RE: **Lot 1 Block 8 S.A.D. 227 Unit 5**
6223 Kayenta Dr. NW
Grading and Drainage Plan
Engineers Stamp Date 3/18/2021 (E10D102)

DRAINAGE AND TRANSPORTATION INFORMATION SHEET (REV 6/2018)

ENGINEER'S SEAL DAVID SOULE NEW MEXICO REGISTERED PROFESSIONAL ENGINEER 3/18/21 DAVID SOULE P.E. #14522	LOT 1 BLK 8 UN 5 VC KEYENTA PLACE NW		DRAWN BY DEM
	GRADING AND DRAINAGE PLAN		DATE 3-18-21
 P.O. BOX 53924 ALBUQUERQUE, NM 87199 (505) 321-9099	SHEET # C1		Lot 1 Blk 8 Un 5 VC.DWG
	JOB #

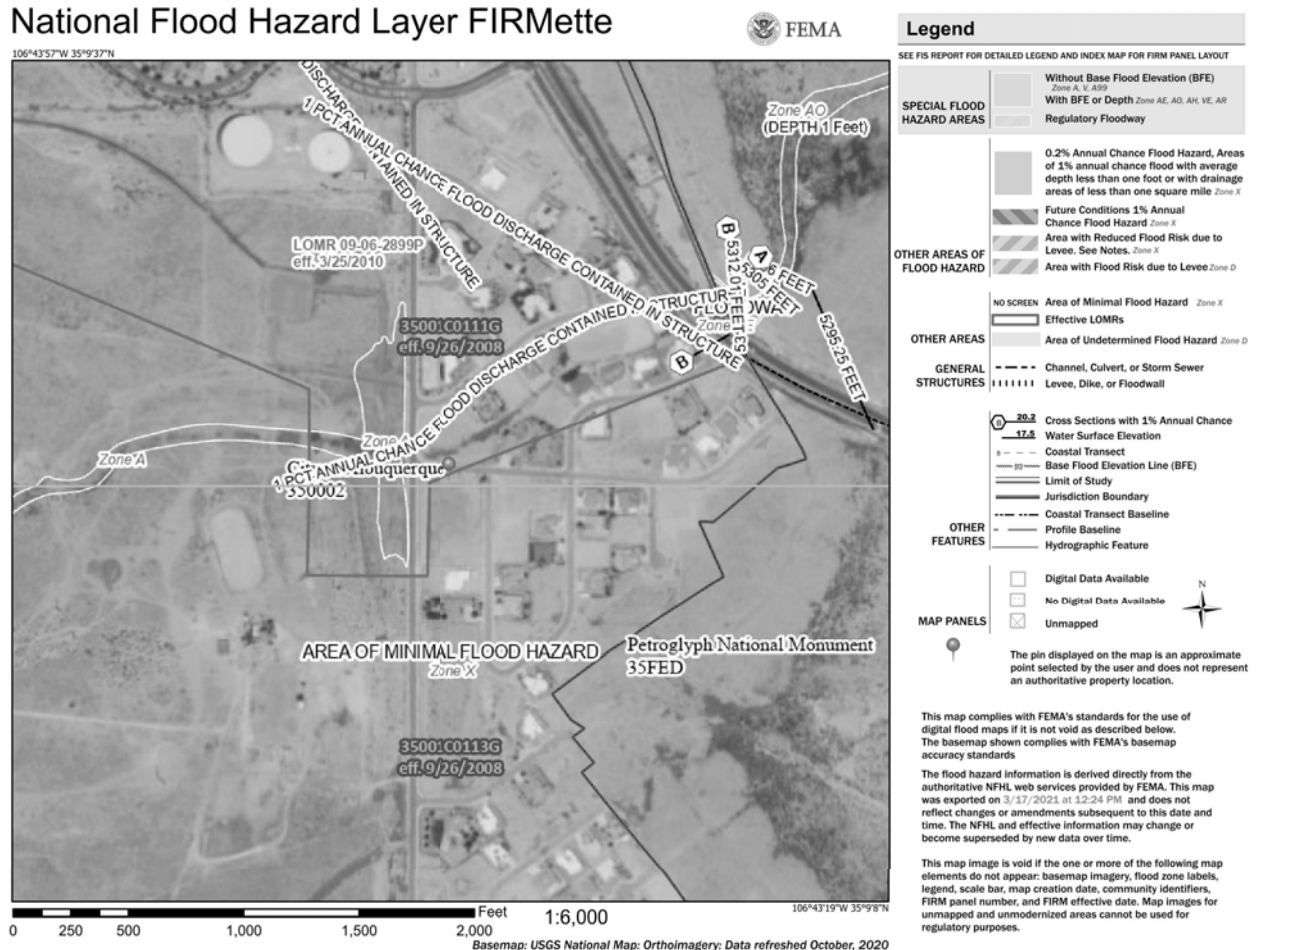
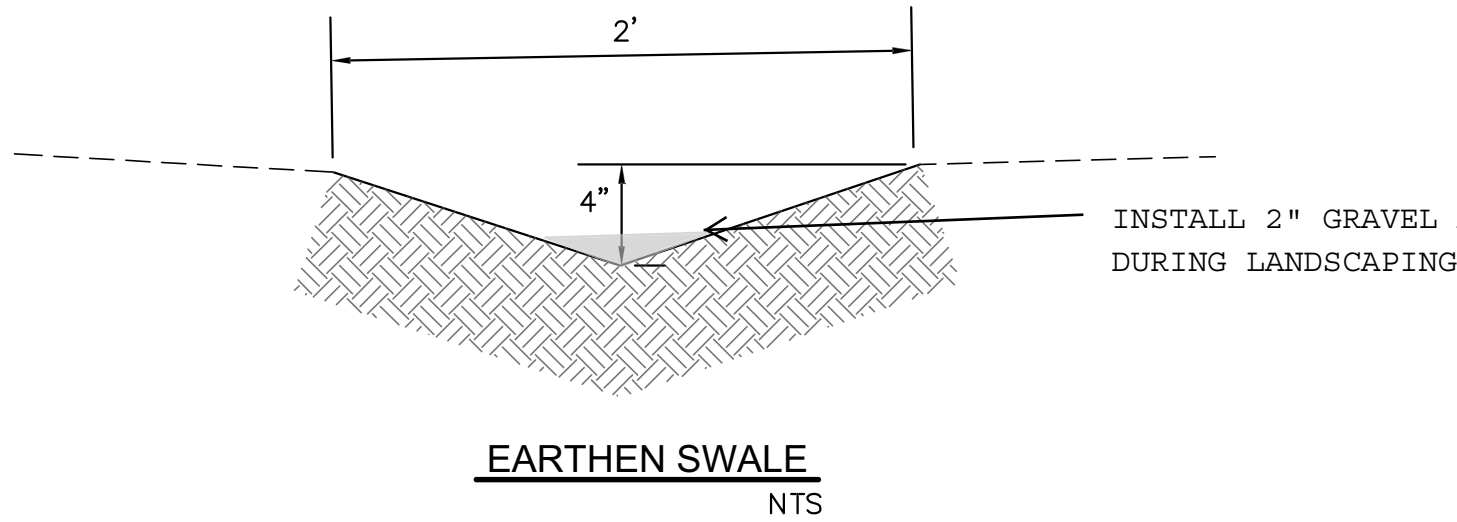
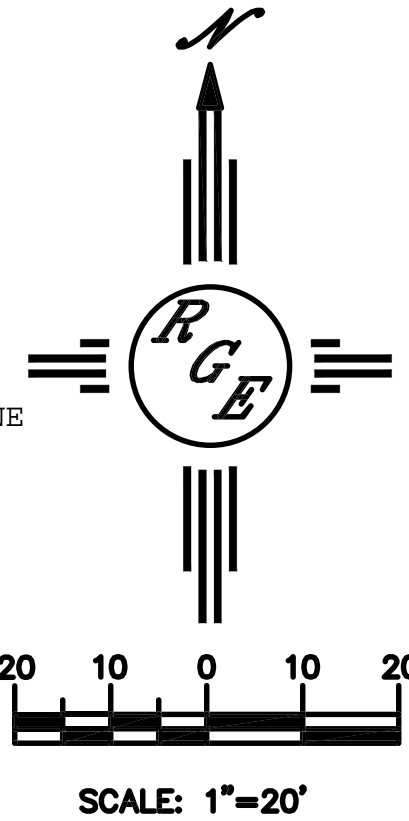
Based upon the information provided in your submittal received 3/22/2021, this plan is approved for Grading Permit. Please inform the builder/owner to attach a copy of this approved plan and letter into the construction sets in the permitting process prior to sign-off by Hydrology.

Reiterate to the Owner/Contractor that a separate permit for any garden/retaining wall must be obtained, with the approved G&D plan. Advise the owner contractor not to use dirt as a ramp to climb the curb, use lumber or crusher fines for this purpose. Also, let the owner/contractor know that if a pool is to be added in the future the G&D plan will need to be modified showing the location of the pool and the land treatment differences.

Prior to Building Permit approval, a **Pad Certification** will be required. Inform the contractor/owner not to pile dirt in the street as a ramp to climb the curb. If dirt is found in the street the pad cert. will be denied.

Prior to **Certificate of Occupancy release**, Engineer Certification per the DPM checklist of this plan will be required.
